Re: Revised Site Plans and Stormwater Management Documentation  
DEP File # 247-1202  
190 Howard Street

- *Stormwater Management Documentation, 190 Howard Street, Northborough, Massachusetts, Connorstone Engineering Inc, 12/2/2021*
- *Site Plan: Proposed Stormwater Plan of 190 Howard Street in Northborough, MA Connorstone Engineering Inc, 12/2/2021*

**PROPOSED STORMWATER PLAN OF 190 HOWARD STREET IN NORTHBOROUGH, MA**

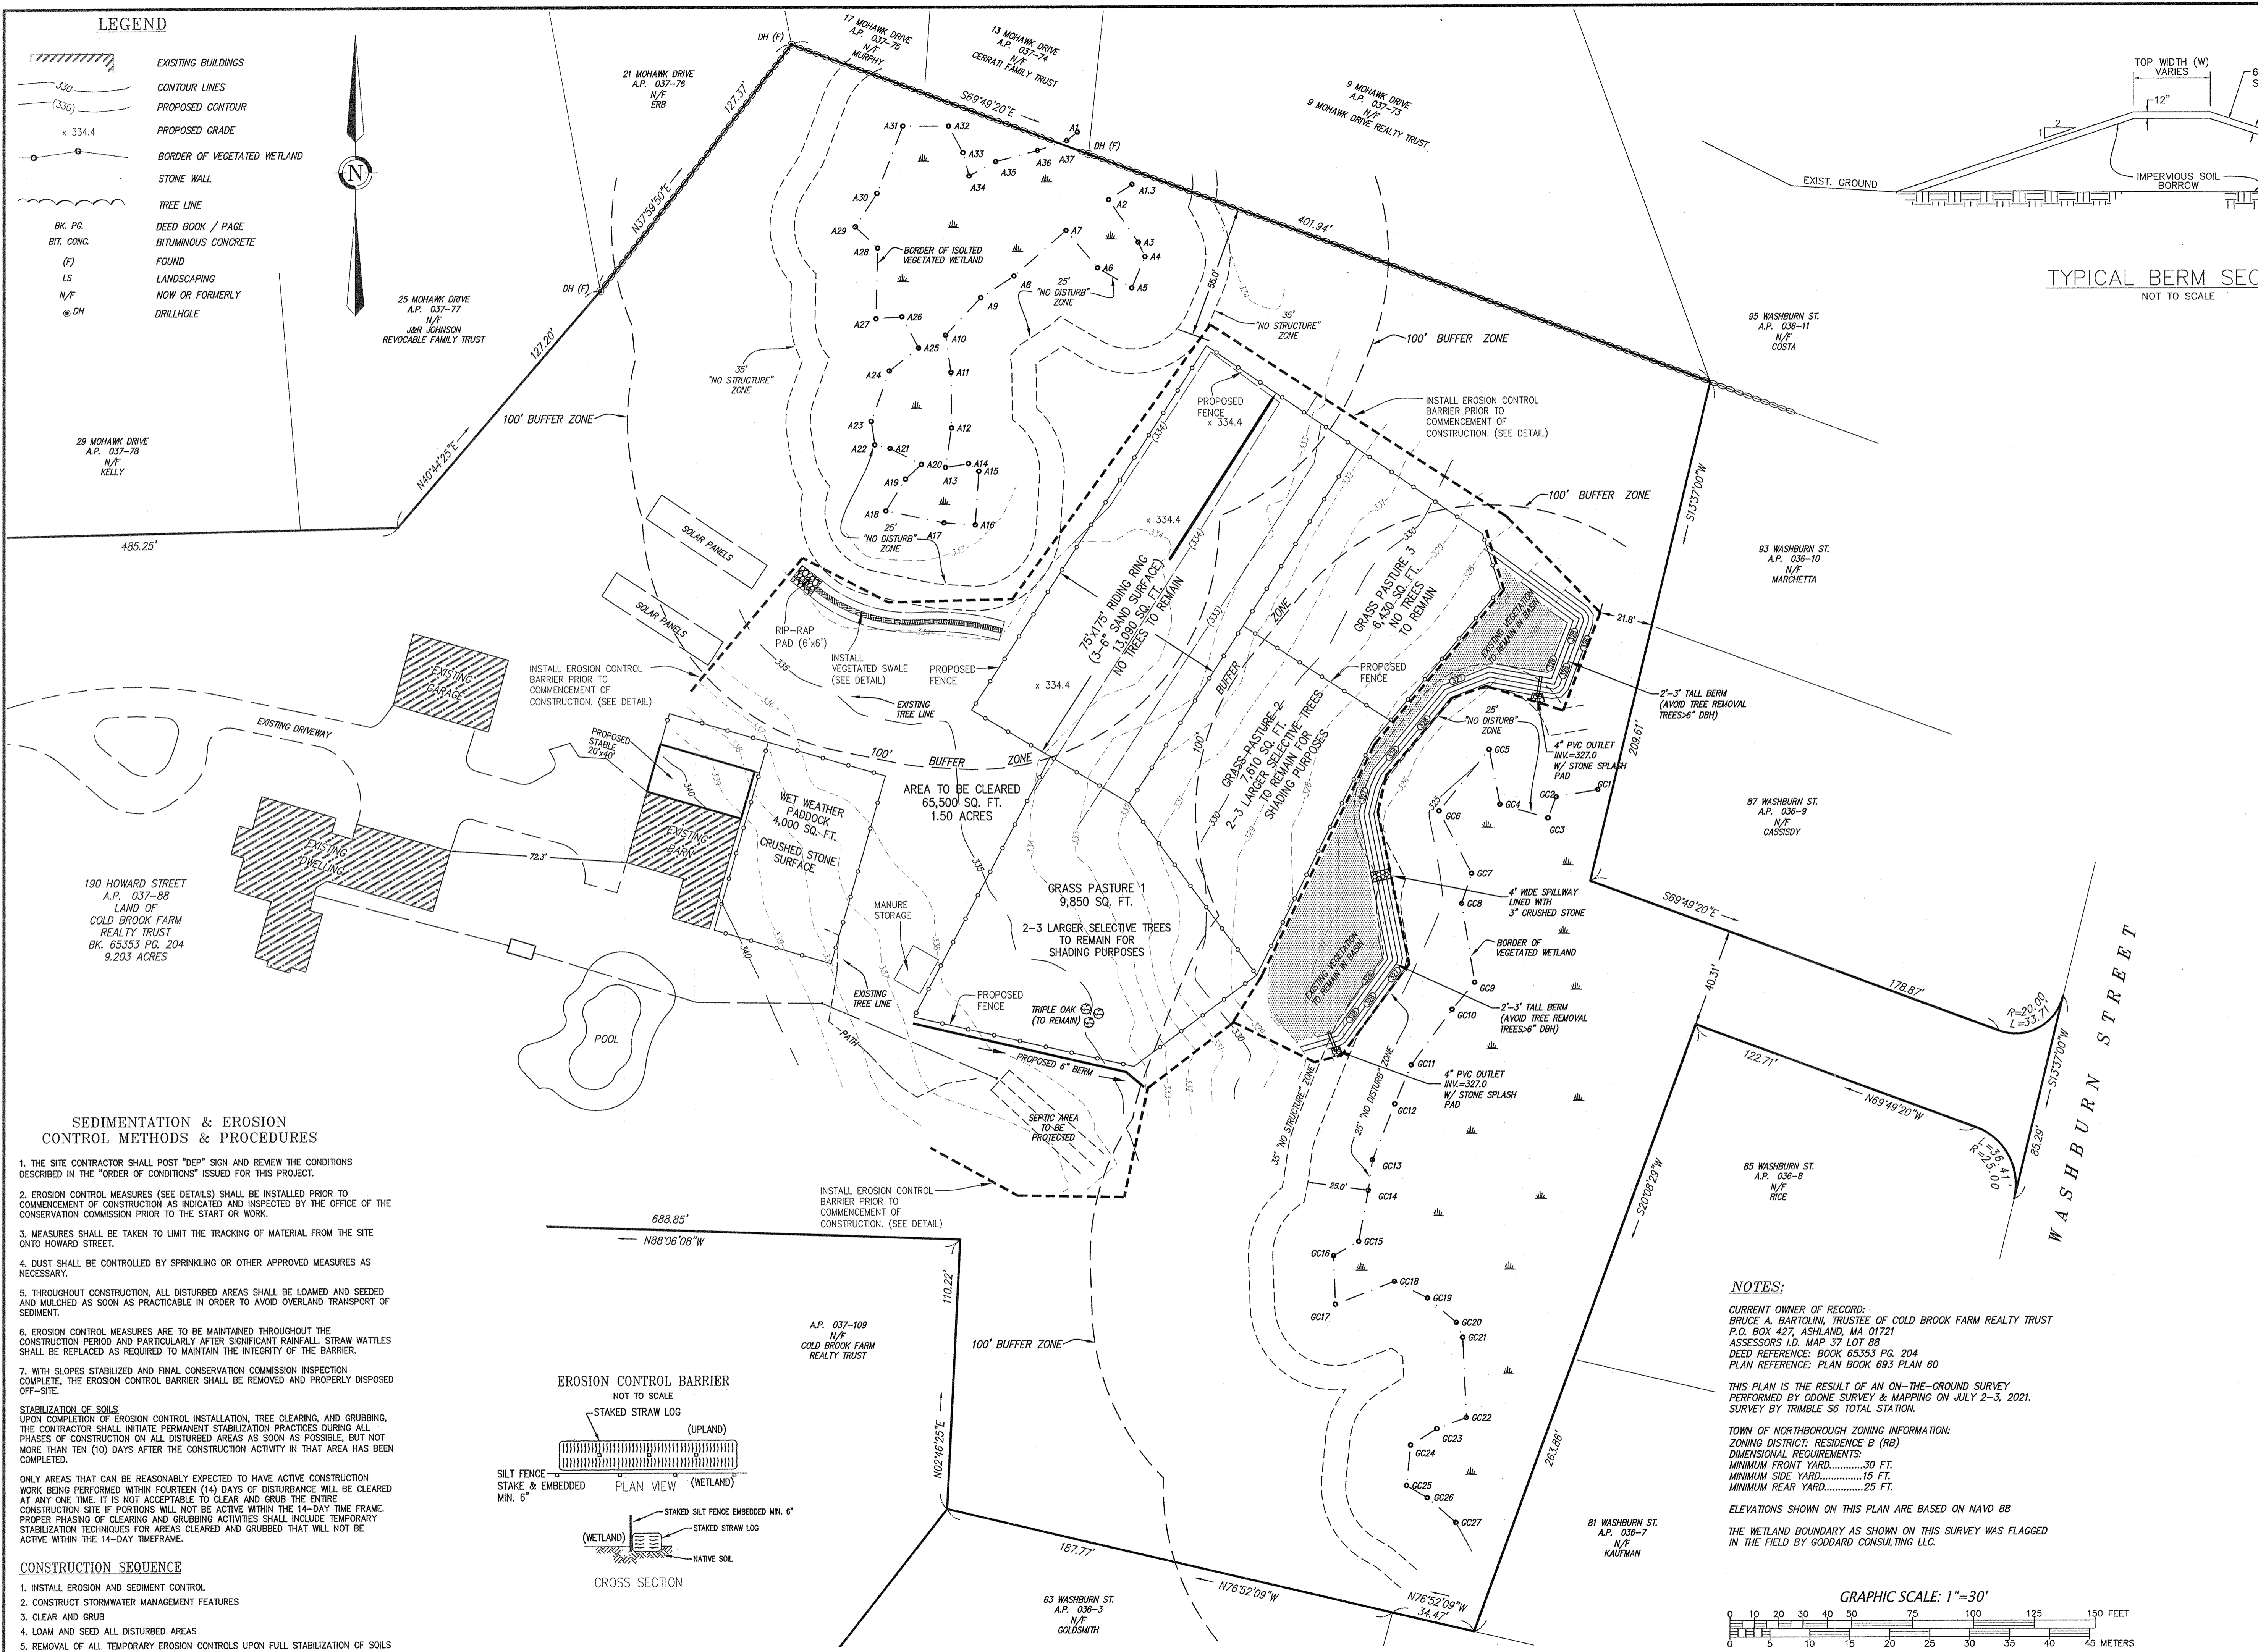
*Clearing should be done in a way that takes care to not destabilize the slope to BVW. The Commission may want to consider 10.53(1) and that "the potential for adverse impacts to the Resource Areas from work in the Buffer Zone may increase with the extent of work..." in its review.*

- The general quantity of trees to remain within each paddock have been shown on the plan to give a general sense of how much mature vegetative cover will remain in each paddock after the initial clearing (see Photo 1).

- The size of each paddock has been added to the plan. It should be noted that the pasture and paddock sizes were designed so that the Applicant will comply with the Northborough Board of Health's Horse and Stable Regulations. Reducing pasture area posed a risk of providing inadequate space for the horses and not complying with the aforementioned regulations.

- A stable has been added directly adjacent to the existing barn to provide shelter for the horses. This stable is outside of the 100-foot Buffer Zone.

- Two berms have been added to the plan. Please see *Stormwater Management Documentation* from Connorstone Engineering Inc (dated 12/2/2021) for a thorough explanation on the design and intent of stormwater management for the site.

- A 6" berm has been proposed at the southern extent of the pastures for the purpose of preventing stormwater flow from entering the paddock area.

- A 2'-3' berm is proposed downgradient of the proposed paddocks just outside the 25-foot Buffer Zone. The berm's intent is to create a stormwater basin/rain garden to control both peak rate of runoff and volume of runoff from the pasture and paddock areas. Existing vegetation will remain in the basins. The berms construction will avoid tree removal for trees greater than 6" in diameter.

- Providing a construction sequence on the site plan to ensure the appropriate erosion and sediment controls are installed prior to any construction and to ensure stormwater management features are constructed prior to significant clearing and grubbing.

- Providing Sedimentation & Erosion Control Methods and Procedures on the site plan to ensure the downgradient resource areas are not impacted by sedimentation and erosion during construction.

- Constructing stormwater management features between the pastures and the downgradient resource areas to control both peak rate of runoff and volume of runoff from the pasture and paddock areas during construction and after project completion.
